INDESIT company

Model type:
WISL85PL

Commercial code:
F030562

N1040319FIG1

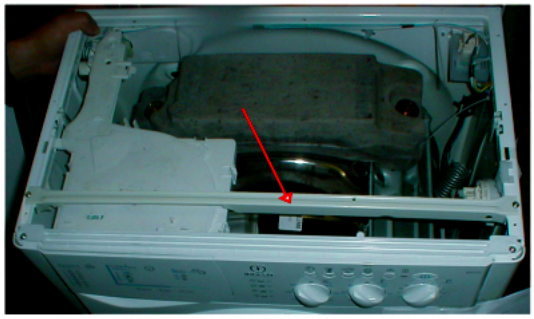
n1040319: Elimination of metal bar on INDESIT cabinets.

From serial no. 40223.0001 Indesit EVOII Washing Machines produced in the Comunanza - Brembate factory have been equipped with a wooden reinforcing strip on the top, whereas the metal bar on the cabinet has been eliminated.

The modified tops have the same Service code as premodification items (096937, 097617, 098440, 099929 and 097806).
When using the new top on a premodification appliance the metal bar (see N1040319FIG1) must be removed, whereas the old top can be used in place of the new one without any modification.
The new top can be used in place of the old one and vice versa; the Service code remains the same.

n1040325: New shock absorber fixing system with pin

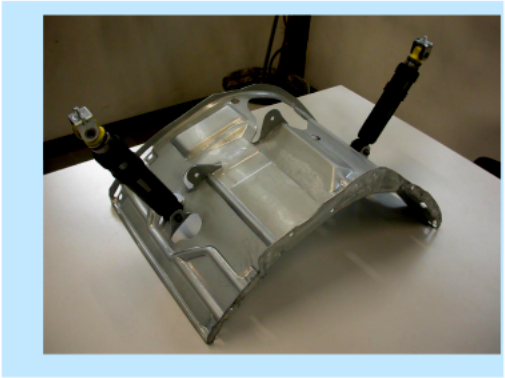
From serial no. 40427.0001, shock absorbers have been fixed to the tank unit cradle with two 11 mm pins code C00110163 (see fig. 01 and 02 enclosed) in place of the 8 mm screws code 093750 and relevant locking nuts code 030443, on all washing machines and dryers produced in the Comunanza factory.
The items affected by this modification are:
1) The cradles have the same Service code, as they can be used in place of the new ones after widening the shock absorber fixing holes to a diameter of 10 mm.
Code 093848 - Tank unit cradle 46 lt
Code 093878 - Tank unit cradle 40 lt.

2) The new shock absorbers, with fixing bushing having no s/steel spacer, are not managed as they are interchangeable with the premodified items (make sure they are CIMA type, as the managed items), fixed with M8 screws code 093750 and related locking nut code 030443 (see figs. 05 and 06).
Code 093884 - Shock absorber 80 N
Code 093885 - Shock absorber 100 N

To remove the shock absorber from the tank, first extract the pin with a few hammer taps (see fig.03) until it is aligned with the tank bracket and then pull it out with a pair of pliers (see fig. 04).
(To refit the shock absorber use a new pin. Insert the pin until the toroidal edge is aligned with the bracket.)

n1040326: Two-bearing mechanism on Slim range washing machines

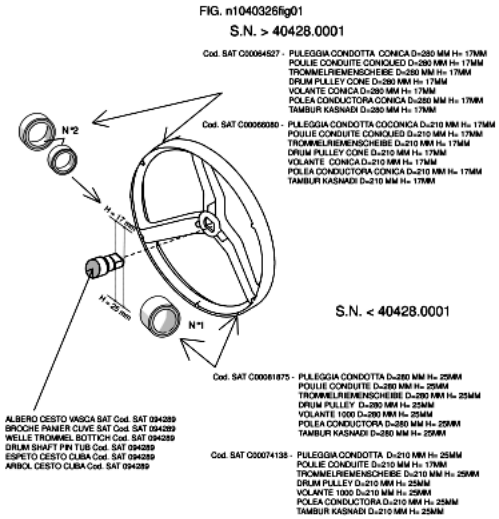
From serial no. 40428.0001, all Slim range models produced in the Comunanza factory have been equipped with a two-bearing mechanism in place of the single-bearing one.

The Service codes of the new mechanism are:
Service code C00096186 - SEAL RING CV4;
Service code C00002591 - BEARING 20X47X14 6204 SKF;
Service code C00013563 - BEARING 25 X52 X 15 6205 - 2Z SKF;
Service code C00110340 - CROSS WITH SEAL RING (2C) SNELLA;
Service code C00094289 - EVO 40L TANK SLIM (1-C) > (2-C)EVOII;
Service code C00094290 - OUTER- SET 40 L.(1-C)>(2-C)EVOII;
Service code C00064527 - DRIVEN PULLEY CONE D=280 MM H= 17MM;
Service code C00066080 - DRIVEN PULLEY CONE D= 210 MM H=17 MM.

The tank assembly with the new two-bearing cross has the same Service code as the single-bearing one (C00094289); the latter will be available until stocks run out.
When replacing the tank, make sure that the value H (17 mm or 25 mm) of the basket cross shaft corresponds to the value H of the pulley (see Fig.001).

The following premodified items will continue to be used:
Service code C00026298 - BEARING BA2B 633667 30X60.03X37;
Service code C00039667 - SEAL RING;
Service code C00074137 - CROSS WITH SEAL RING;
Service code C00081875 - DRIVEN PULLEY D=280MM H=25MM;
Service code C00074138 - DRIVEN PULLEY D = 210MM H=25MM;
Service code C00026299 - SEEGER RING SB 60X1,5.

n1040359: Polar White Factory 80 (Comunanza)

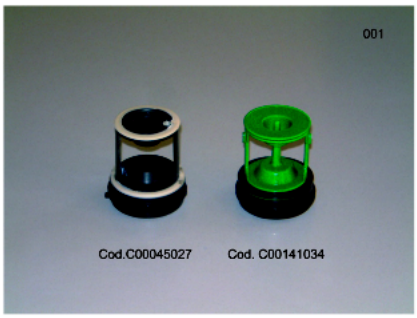
From serial no. 50315.0001, the new "Polar White" colour is used on all washing machines and washer-dryers produced in factory 80 in place of White 27.
The third last number of the Industrial Code given on the rating plate of the modified models is 9 (e.g. 80286390900).
To determine the new Polar White codes, it is necessary to know the industrial code or serial number of the appliance being repaired.
The new items, which bear the initials "PW" in place of "B27", are not aesthetically interchangeable with premodification items as the whites are different. Both colours will be available for some time.
The items affected by this modification are:
Body, rear panel, top, control panel, handles, buttons, knobs, knob disc, door and plinth.
